Tuesday 26 March, 2013

Colong Foundation response to the Coalpac submission in reply to the PAC review report and recommended refusal of the proposed Consolidation Project for an open-cut coal mine in Ben Bullen State Forest

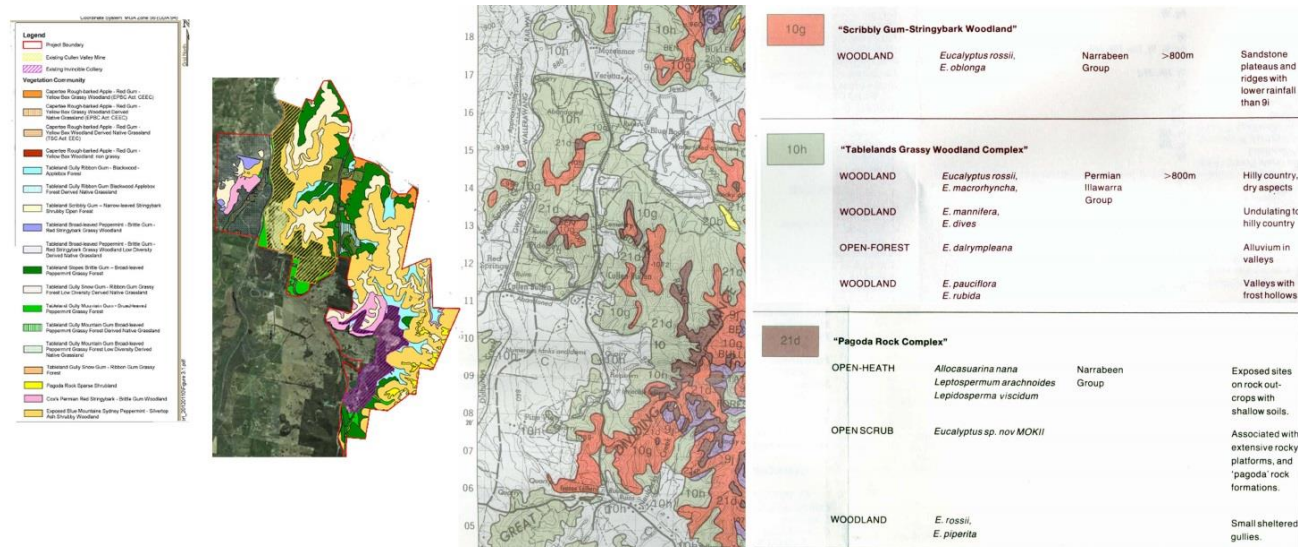
Cumberland Ecology in Appendix E, Section 5.1.4, page 5.15, in reply to the Coalpac PAC report writes: 'The slopes and forested valley floor has been mapped as "10i Talus-slope Woodland" not "10h Tableland Grassy Woodland Complex" by Benson and Keith (1990) (see Figure 5.3)'. This comment is incorrect.

Further, Cumberland Ecology also remarks: 'the "10h Tableland Grassy Woodland Complex" does not occur in the Project Boundary or adjacent the Project Boundary (Figure 5.3).' This unequivocal statement is also incorrect.

The Figure 5.3 has different vegetation typing to the map published in *Cunninghamia* Volume 2, Number 2, 1990 for the same shaped areas. Cumberland Ecology should have checked with the published map in *Cunninghamia* Volume 2, Number 2, 1990, before making the above statements.

Cumberland Ecology has not explained how the areas shown as "10h" on the 1990 published map have become areas of "10i" on its map in Figure 5.3, Appendix E, published in March 2013. The "10h" vegetation type is quite rare, however "10i" is common, so this difference is important, as the Colong Foundation explained in a previous submission.

The Colong Foundation for Wilderness considers the omission of an explanation for the change in vegetation typing made in figure 5.3 by Cumberland Ecology could be an example of unprofessional conduct. The Foundation hopes that DoPI and/or PAC2 will obtain an explanation from Cumberland Ecology for this unfortunate mapping error.

The area 'Tablelands Grassy Woodland Complex' is mapped 10h (rare) in 1990 and in 2012 is mapped as Exposed Blue Mountains Sydney Peppermint - Silvertop Ash Shrubby Woodland (very common)

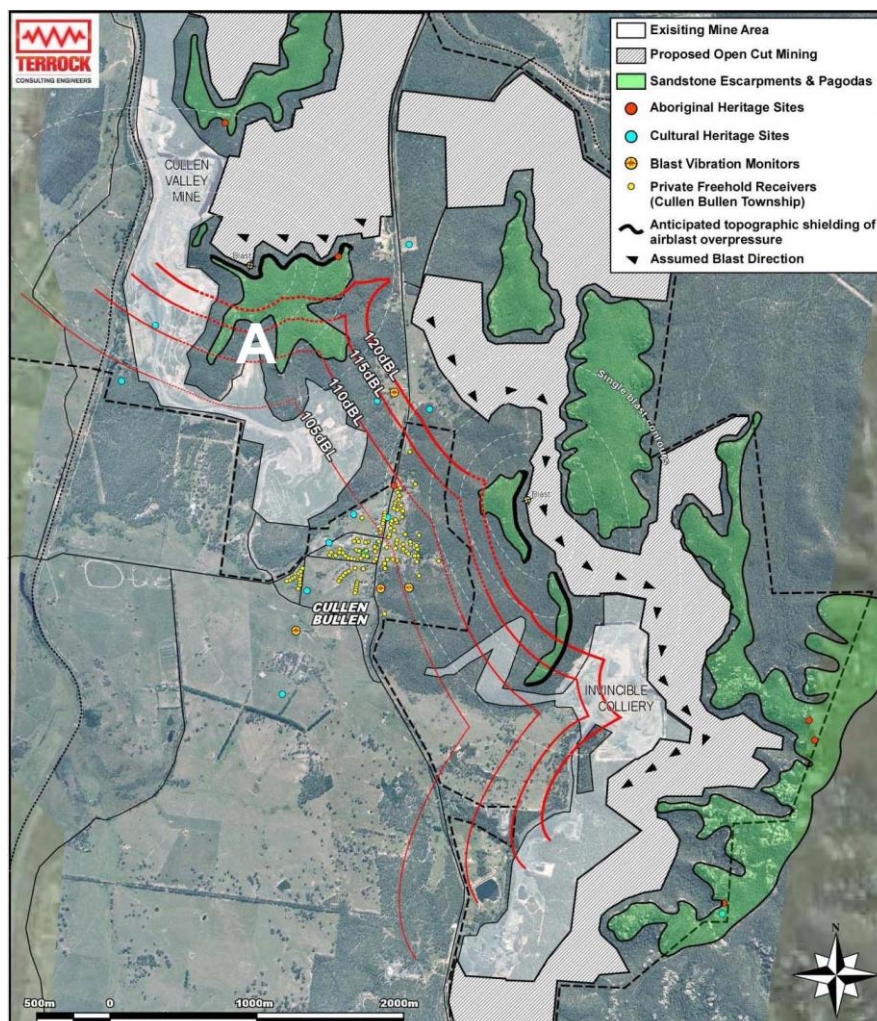
The above, Figure 7B in Appendix D of the Coalpac submission in reply, reveals that Terrock is mapping what appears to be buffers in relation to “pagodas and sandstone escarpments” beyond the SPL area. Coalpac apparently wishes to define these ‘buffers’ out of existence as indicated by Hansen Bailey submission in reply Figures 7A and 7B.

I have marked with a white capital “A” the apparent buffer for the previous mining at Cullen Bullen that look, judging by reference to the scale in the figure, to be up to 300 metres wide in relation to the areas mapped as “pagodas and sandstone escarpments”.

Coalpac appears to be winding back buffer protection that has been previously adopted either voluntarily or as prescribed for its Cullen Bullen open-cut mine. Coalpac has wound back protection on previous occasions through a succession of development consent modifications at Invincible Mine, as I have mentioned in a previous submission.

The consistent adoption of a 300 metre buffer, like at “A”, as proposed by the PAC1 Report would apparently render the proposed open-cut area unviable. In response the proponent has abandoned buffers altogether. The Colong Foundation believes the revised development proposal should be refused consent as Coalpac and its consultants seek to reduce previous levels of environmental protection in this environmentally sensitive area.

Given the above Terrock Figure 7B and the obvious considerations behind it, the Colong Foundation is very disappointed by the minimal nature of this concession offered to protect the Gardens of Stone reserve proposal, 2005. The environment groups anticipated that any efforts to revise the mining proposal would address the area within the Gardens of Stone reserve proposal.

Further, while the text states that highwall mining will not occur in the SPL, figure 7B shows otherwise. Given Coalpac’s past behaviour regarding development, the miner is very likely to seek a subsequent development modification to mine the SPL area by highwall method and to vary open-cut mining areas given the removal of buffers. In fact, the reason for omitting buffers would seem to be to remove certainty of protection and the idea of protection zones, apart from the SPL.
